*Misleading Signs*

### *Non-compliant Signs*

Photograph G: Advanced curve warning and horizontal curve chevron with non-standard advisory speeds of 60 kph.

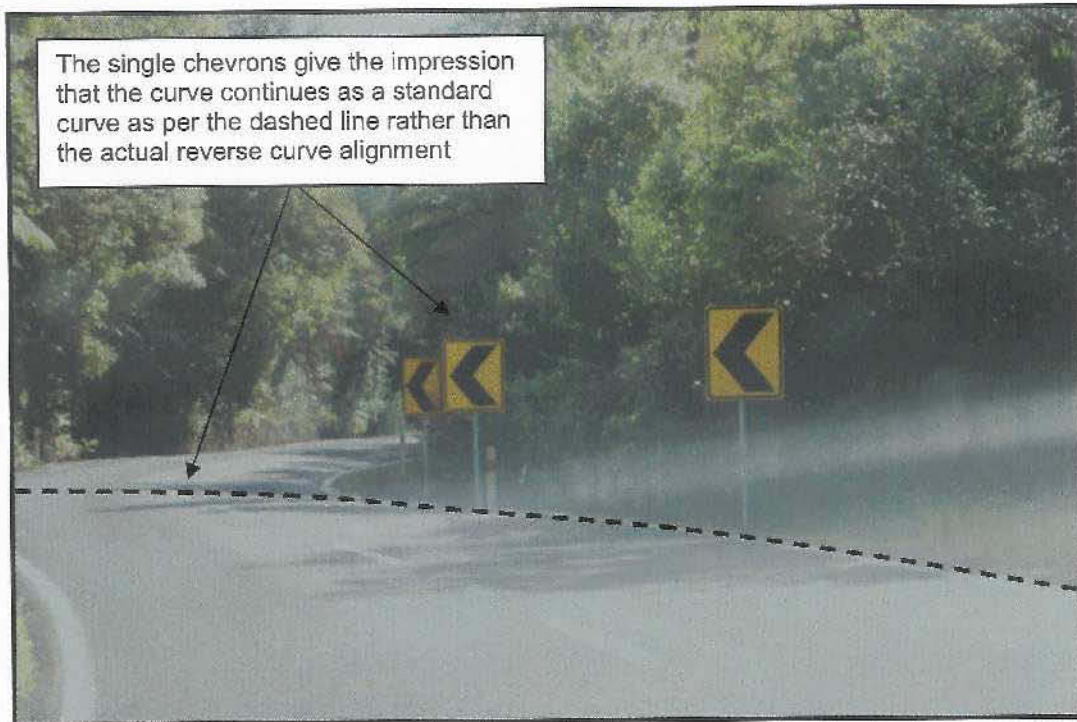
It is also noted that a number of the bends on the roads have curve advisory speeds with multiples of ten (i.e. 40, 50, 60). The Manual of Traffic Signs and Markings (MOTSAM) specifies that advisory speeds should end with a five (i.e. 45, 55, 65) and hence these signs do not strictly comply with MOTSAM.

The costs associated with correcting non-compliant signs are not considered justified, mainly because the technical non-compliances are not likely to cause a significant safety issues. However advisory speed signs with multiples of 10 kph should be corrected when any new advisory speeds are installed or replaced.
